STABILIZERS - HORIZONTAL FASTENER REPLACEMENT

MODEL	SERIAL NUMBERS
B200GT	BY-434 thru BY-444
B300	FL-1301 thru FL-1309
B300C	FM-108, FM-109

MTL-55-02
Page 1 of 6

Figure 1. Horizontal Fastener Location (Sheet 1)

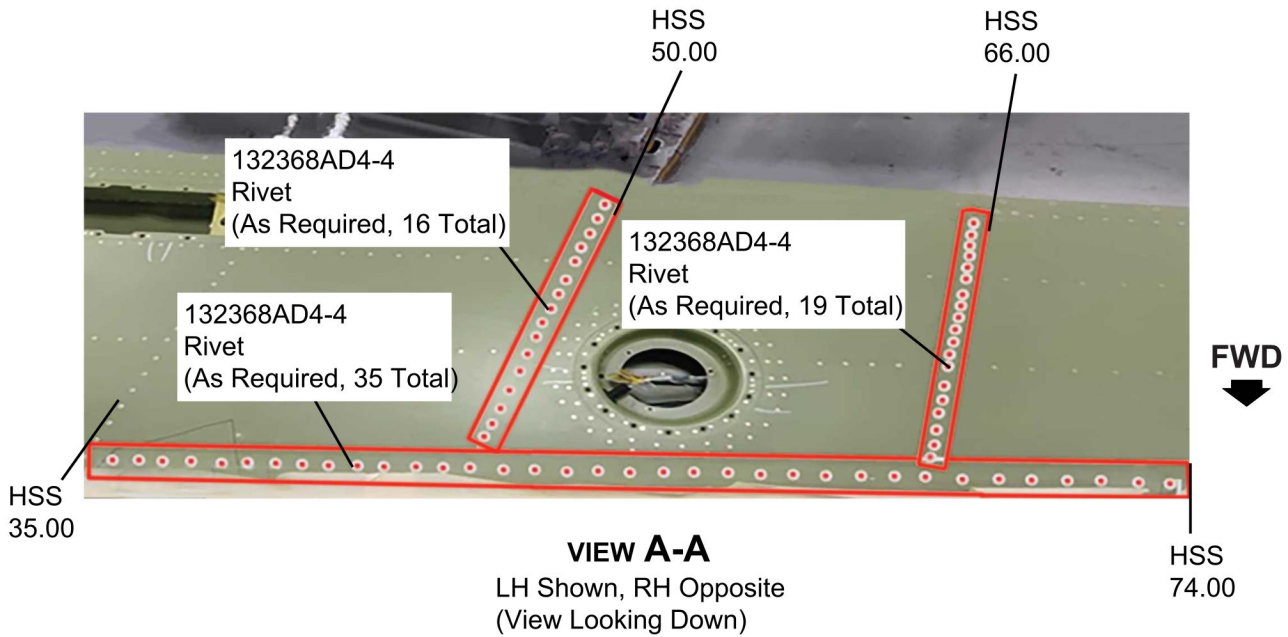
NOTE: The highlighted red areas of Figure 1, Sheet 1 located on the upper surfaces of the left and right horizontal stabilizers are the areas that need to be inspected with a magnet.

NOTE: Only the areas highlighted in red needs to be inspected for magnetic fasteners.

- A. If all the fasteners are non-magnetic, then go to Step 4.
 - B. If any of the fasteners are magnetic between HSS 35.00 and HSS 74.00 on the upper surface and between HSS 35.00 and HSS 66.00 on the trailing edge of the left horizontal stabilizer, go to Step 3.
3. (Refer to Figure 1, Sheet 2.) Replace any of the magnetic fasteners as follows:
 - A. For magnetic fasteners on the upper surface of the left horizontal stabilizer between HSS 35.00 and HSS 74.00 do as follows:
 - (1) Remove the access panels 352EBR, 352DBR, 352CBR as required from the left horizontal stabilizer. (Refer to the applicable Maintenance Manual, Chapter 6, Airplane Access Panels - Description and Operation.)

Figure 1. Horizontal Fastener Location (Sheet 2)

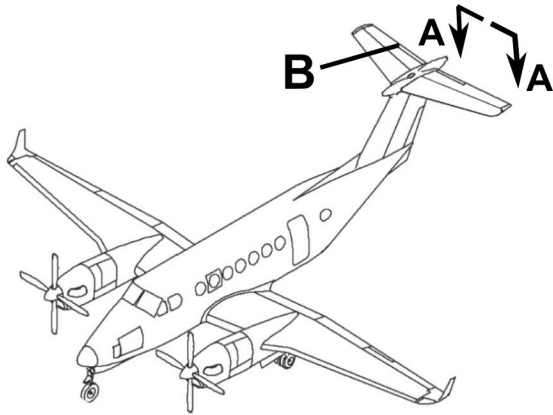
- B. For magnetic fasteners on the trailing edge of the left between HSS 35.00 and HSS 66.00 on the trailing edge of the left horizontal stabilizer do as follows:

NOTE: Only the rivets that attach the 101-620010-9 Cove Closure needs to be inspected on the upper surface.

- (1) Remove the left elevator if required. (Refer to the applicable Maintenance Manual, Chapter 27, Elevator - Removal/Installation.)
- (2) Remove all attach fasteners from the 101-620010-9 Cove Closure. (Refer to the King Air Structural Inspection and Repair Manual, Chapter 20, Fastener Installation and Removal.)
- (3) Remove all foreign object debris (FOD).
- (4) Apply Color Chemical Film Treatment to the rivet holes.
- (5) Apply Corrosion-Resistant Epoxy Primer to the rivet holes.
- (6) Install the 101-620010-9 Cove Closure with a NAS1739E-4-4 Rivet into all open rivet holes. (Refer to the King Air Structural Inspection and Repair Manual, Chapter 20, Fastener Installation and Removal.)
